T I T L E : AIR CONDITIONING - AIR COOLING SYSTEM - IMPROVE RAM AIR OUTLET

MODIFICATION No.: 22995K2883

Herewith Revision No. 2 of Service Bulletin A320-21-1051.

SERVICE BULLETIN No.: A320-21-1051

Removal/Installation of the Flap and Lever Figure 1, Sheet 2 of 2

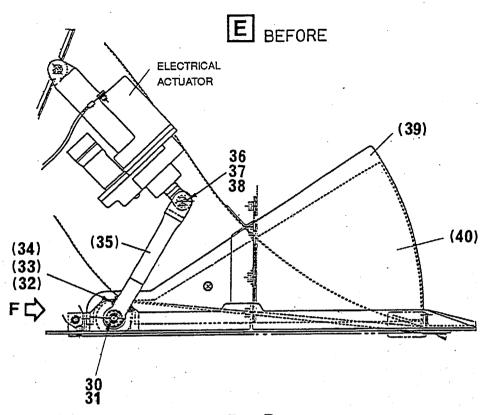
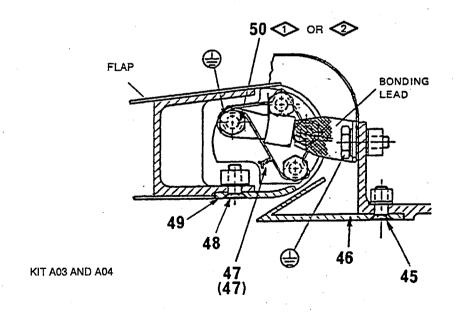
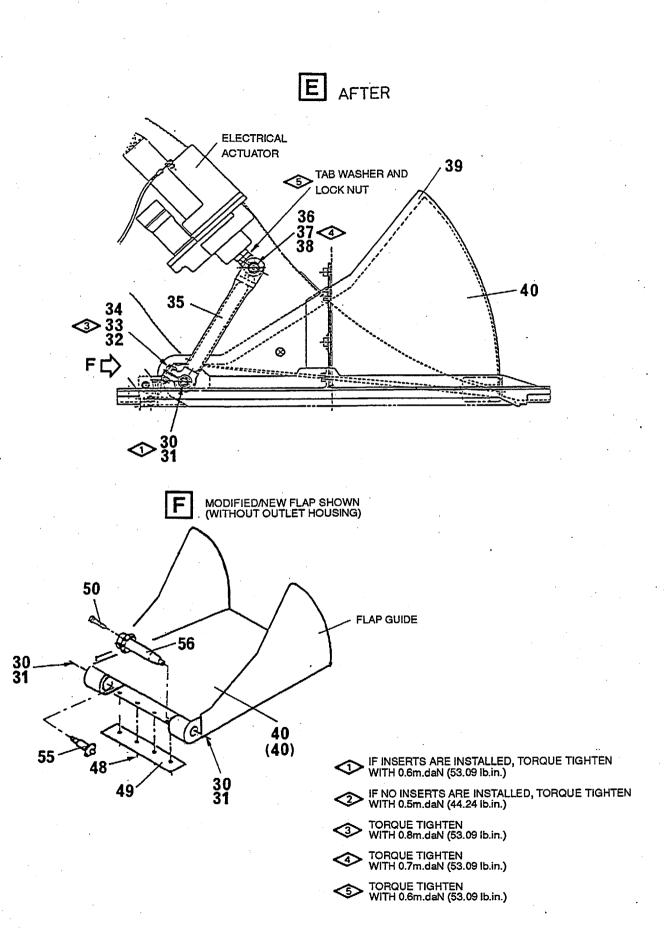
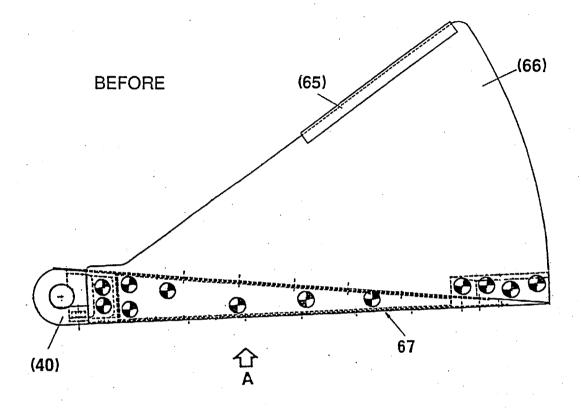
Refer to Figure 1, details C, E and F and section B-B.

- (a) Disconnect the bonding lead, item 10 from the electrical actuator 9HH (29HH).
- (b) Remove the electrical actuator 9HH (29HH) in accordance with the AMM 21-62-52, P. Block 401; retain the electrical actuator and the fastening parts, items 36 thru 38 for later re-installation.
- (c) Remove and discard the lever, item (35) with fastening parts, items 30 thru 34 and retain the fastening parts, items 30 and 31.
- (d) Remove the cover plates, items 46 and 49 and retain with fastening parts.
- (e) Remove and discard the Lockwire, item (47).
- (f) Remove the flap, item (40) with shafts, items 56 and 55 and fastening parts, items 50, 30 and 31. Retain both shafts and fastening parts.

B-B BEFORE/AFTER

- (a) Install the new or modified flap D2157103000200, item 40 with retained shafts, items 55 and 56 and the retained fastening parts.
- (b) Torque tighten the bolts, item 50 to 0.6 m.daN (53.09 lb.in.).
- (c) Secure the bolts, item 50 with lockwire LN9224.1.4314.9-0.8, or AMS4026, item 47.
- (d) Install the electrical actuator 9HH (29HH) with retained fastening parts, items 36 thru 38 and in accordance with the AMM 21-62-52, P. Block 401.
- (e) Install the new lever D2157104600400, item 35 with bolt NSA1304-8, item 34, nut NAS509-04, item 32 and lock washer NSA5355-4CA, item 33 temporarily on the shaft, item 56.

(f) Connect the lever, item (35) with the retained fastening parts and bushes, items 36 thru 38, at the electrical actuator.

Modification of the Flap Figure 2, Sheet 1 of 3

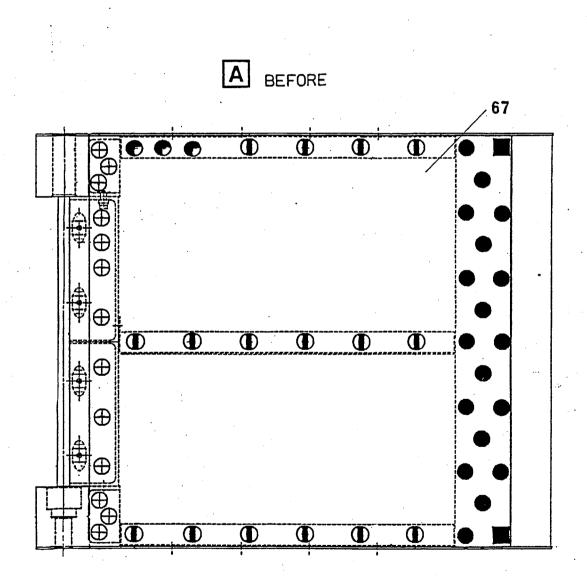
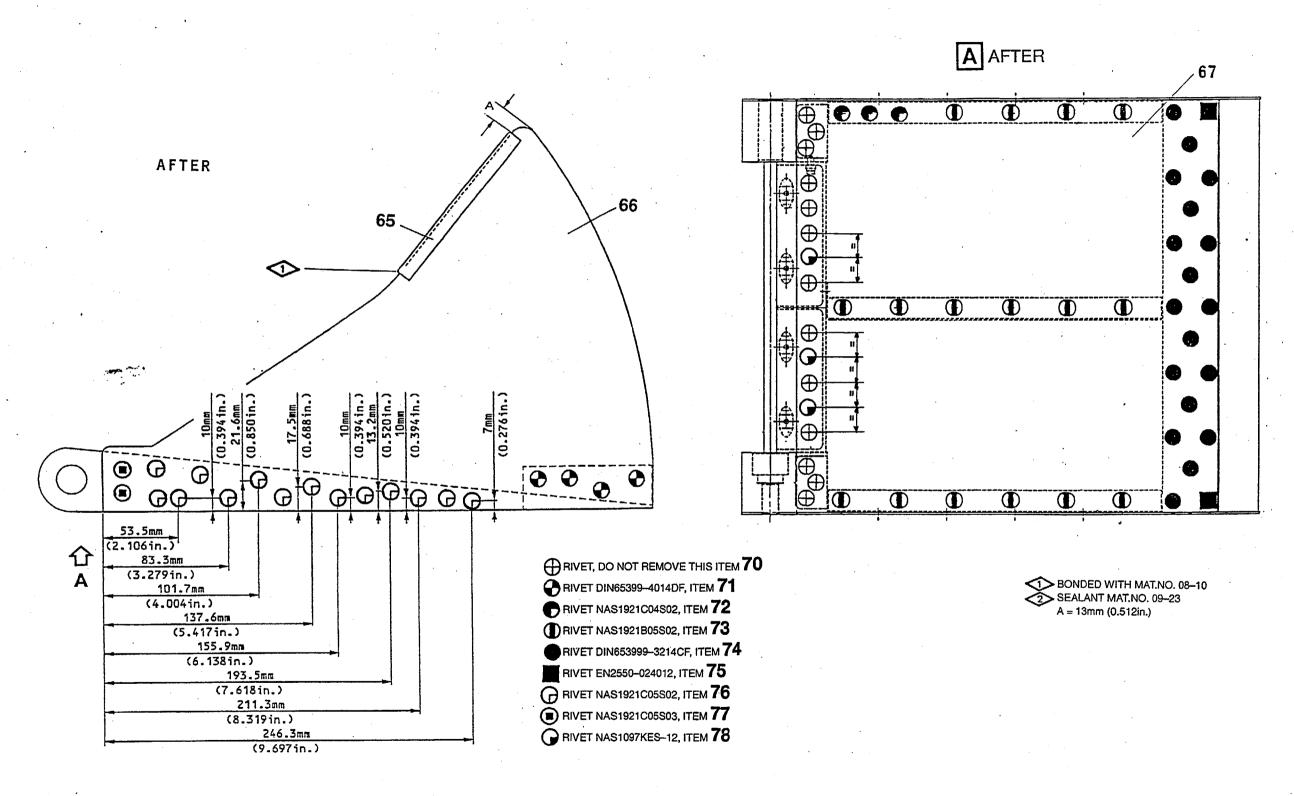
(a) Remove and discard rivets, items (71) thru (75) and both flap guide plates, item (66).

RIVET, DO NOT REMOVE THIS ITEM **70**RIVET DIN65399–4014DF, ITEM **(71)**RIVET NAS1921C04S02, ITEM **(72)**RIVET NAS1921B05S02, ITEM **(73)**RIVET DIN653999–3214CF, ITEM **(74)**RIVET EN2550–024012, ITEM **(75)**

(b) Drill additional rivet holes and install new flap guide plates D2157103520800, item 66 with rivets, items 71 thru 78 and sealant Mat. No. 09-023.

- (c) Bond the profiles D2157103020200, item 65 to the flap guides with bonding compound Mat. No. 08-010.
- (d) Renew the protective finish.
- (e) Re-identify the flaps as per Para. 3.D.

Ram Air Outlet Flap - Install Inserts Figure 2, Sheet 3 of 3

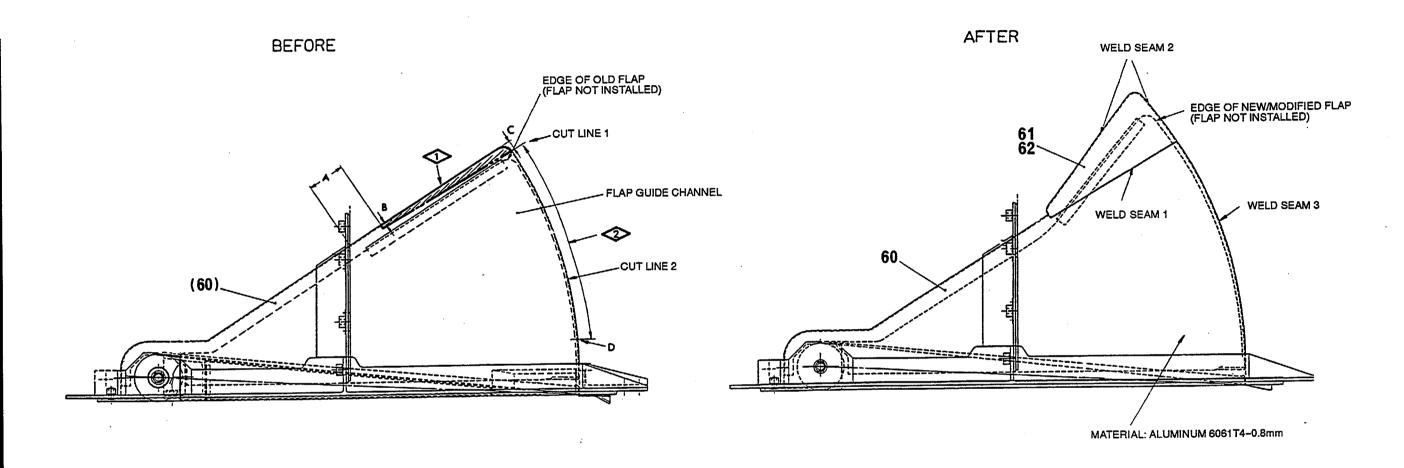
Page	27/28	Figure 2, Sheet 3 of 3	- Qty of sheets amended.
_		Figure_4	- Deleted.
Page	32	Para. 3.A.	<ul> <li>PN of rivet, item 73, changed from NSA54216-040-030 to NAS1921B05S02, Qty of item 71 enlarged. Rivets, item 76, item 77 and item 78 added.</li> </ul>
Page	33	Para. 3.C.	<ul> <li>Equivalent Lockwire AMS4026 added</li> </ul>

A = 5mm (0.197in.) B = 14.1mm (0.555in.) C = 10.5mm (0.413in.)

NOTE: For installation of the inserts and lever refer to Service Bulletin A320-21-1098.

Manufacture of Modification Parts Figure 3, Sheet 2 of 2

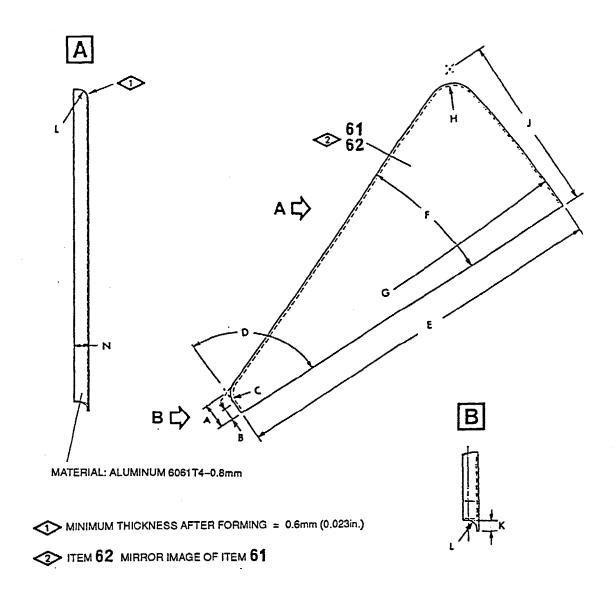
(a) Manufacture two parts each of items 61 and 62; shown on sheet 2. Material and dimensions are given in the figure.

A = 9.4mm (0.370in.)
B = 4.7mm (0.185in.)
C = R.6mm (R 0.236in.)
D = 92.1°
E = 139.4mm (5.488in.)
F = 23°
G = R.396.3mm (R 15.602in.)
H = R.8mm (R 0.314in.)
J = 65.8mm (2.590in.)
K = 4mm (0.157in.)
L = R.3mm (R 0.118in.)
N = 5.5 + 0.2mm (0.216 + 0.0078in.)

NOTE: TWO EACH PER FLAP GUIDE CHANNEL, I.E. FOUR EACH FOR ONE RAM AIR OUTLET NECCESSARY
